CITY OF SAN ANTONIO

Re: Culebra Creek (Amendment) MDP # 773-A

The City Staff Planning Review Committee has reviewed the Culebra Creek Master Development Plan, M.D.P. (Amendment) # 773-A. Please find enclosed a signed copy for your files. Your plan was accepted, however please note the following:

MASTER DEVELOPMENT PLAN for CULEBRA CREEK 773-A

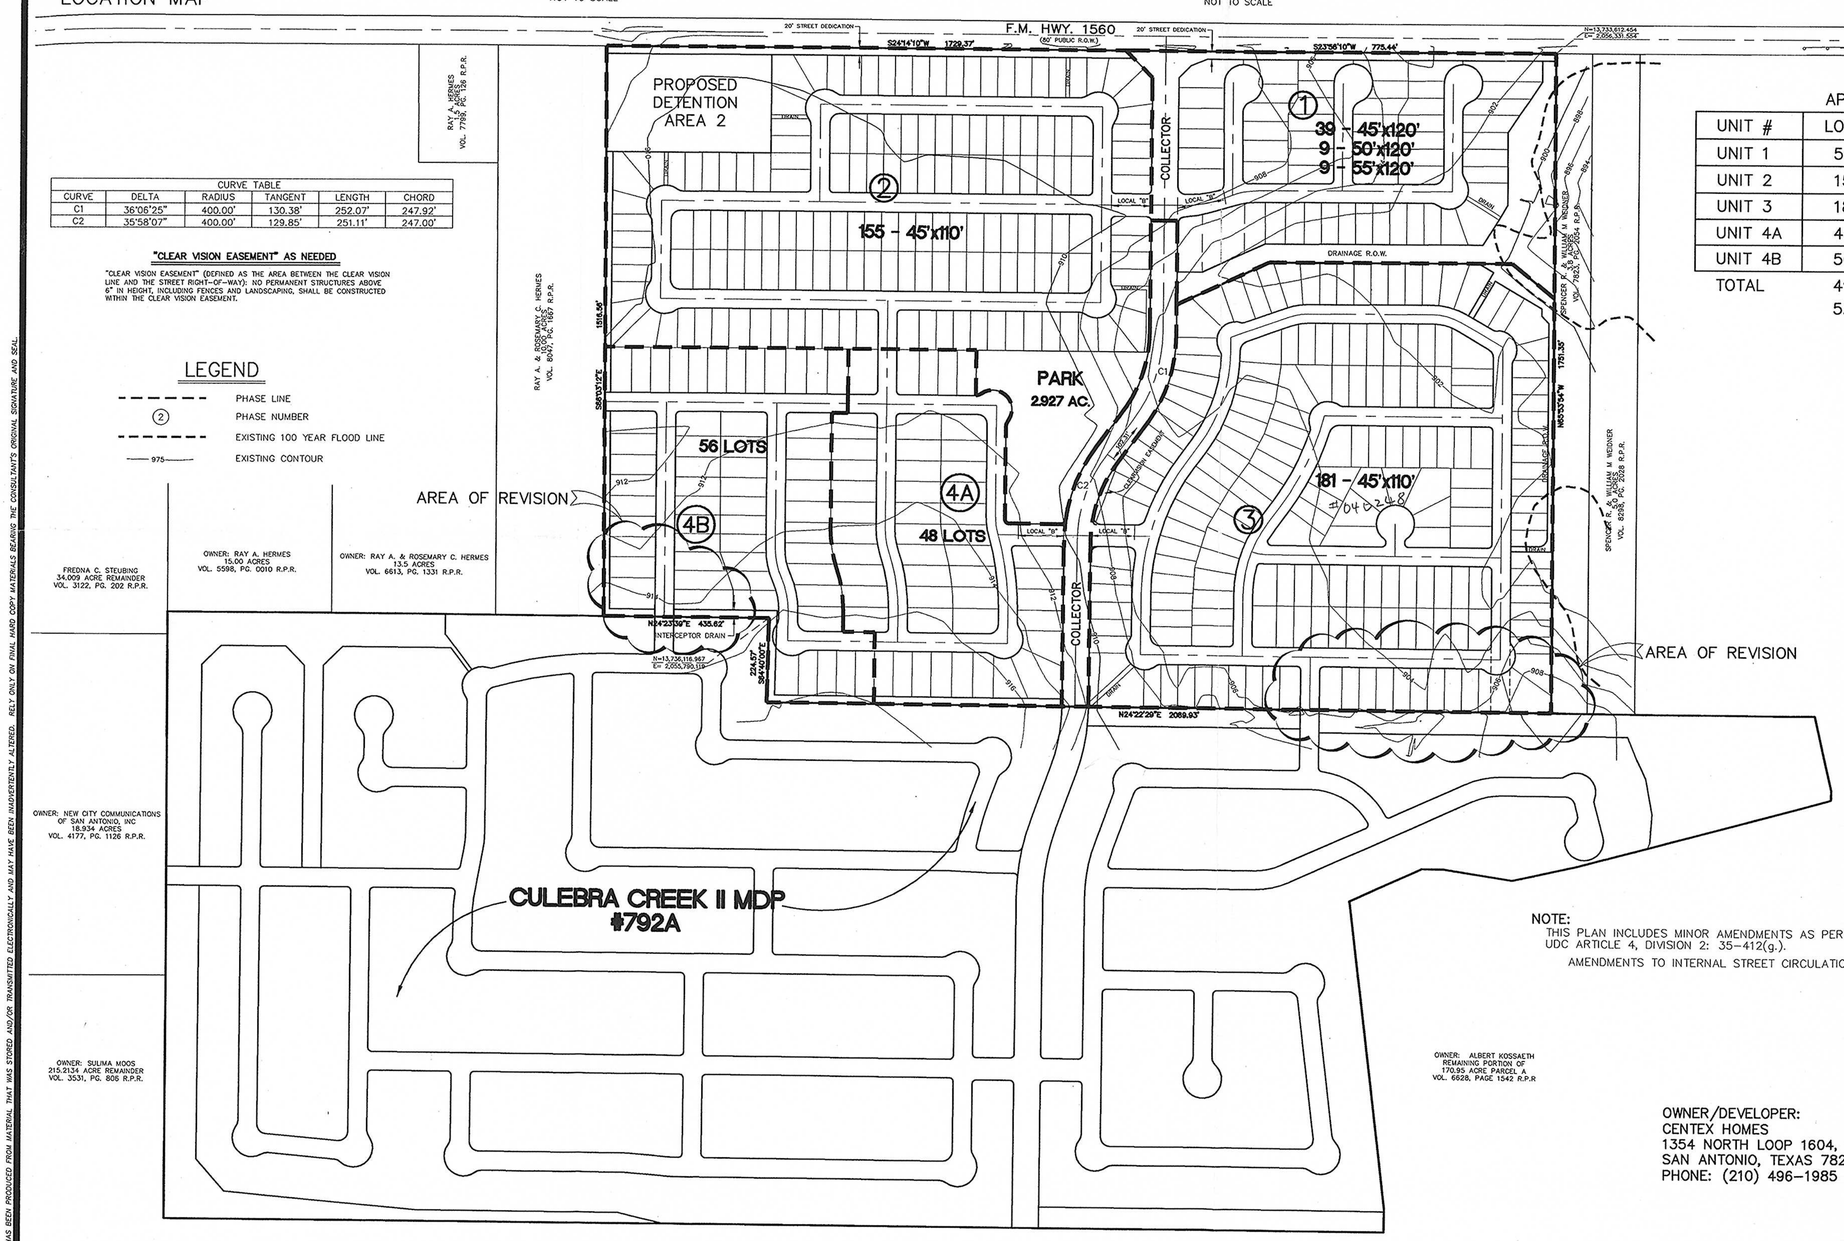
- In consideration of public safety and convenience, excessive grades by reason of topography should be avoided in street layouts and arrangements.

1. It should also be understood that this is a conceptual plan and that all UDC Requirements will be implemented for all plats, within the limits of this MDP. This includes such items as intersection sight distances, street design and pavement requirements, traffic calming, cul-de-sac requirements, right-of-way requirements and widening for a left turn lane and right turn deceleration lane.

2. All Roadways shall conform to Table 506-1: Functional System Description.

- Any access and R.O.W. issues along state facilities will need to be resolved with the Texas Department of Transportation (TXDOT). For information about these requirements you can contact TXDOT at 615-5814.

- This development will need to comply with tree preservation ordinance #85262. For information about these requirements you can contact Tree Preservation at 207-1111.

- It will be expected that you will plat all of the property depicted in your Master Development Plan (M.D.P.) to include floodplains, drainage areas and open space.

The Parks Department cites the following:
Culebra Creek is a subdivision of 497 units. Based on Section 35-503 of the UDC, the park dedication requirement for this development is 4.4 acres.

1. Dedication of 2.927-acre park to the Culebra Creek Homeowner's Association. Dedication to be in compliance with requirements set forth in 35-503(f)(2).

2. Trees shall be planted parallel to all perimeter right of ways. Trees are to be a minimum caliper of 3 inches and planted approximately 35 feet on center. Trees may be of the following species: Cedar Elm, Live Oak, Red Oak, Chinquapin Oak, or Monterrey Oak. Developer to guarantee all trees for a period of one year from installation.

3. Park to include at least three of the following improvements: playground, informal play area, trail, parking/access control, park furnishings, or landscaping. Improvements to be submitted with Unit 2 and approved by the Parks Department.

4. Fee in-lieu of dedication in the amount of $13,846.20. Fee must be paid prior to recordation of the first plat filed under this plan.

1. The floodplain limits on this Master Development Plan (MDP) are estimated and subject to change. Approval of subdivision plats associated with Master development plan will be subject to the review and approval of a Storm Water Management plan in accordance with appendix B, section 35-B119 of the city of San Antonio Unified Development Code (UDC).

2. Detention is proposed.
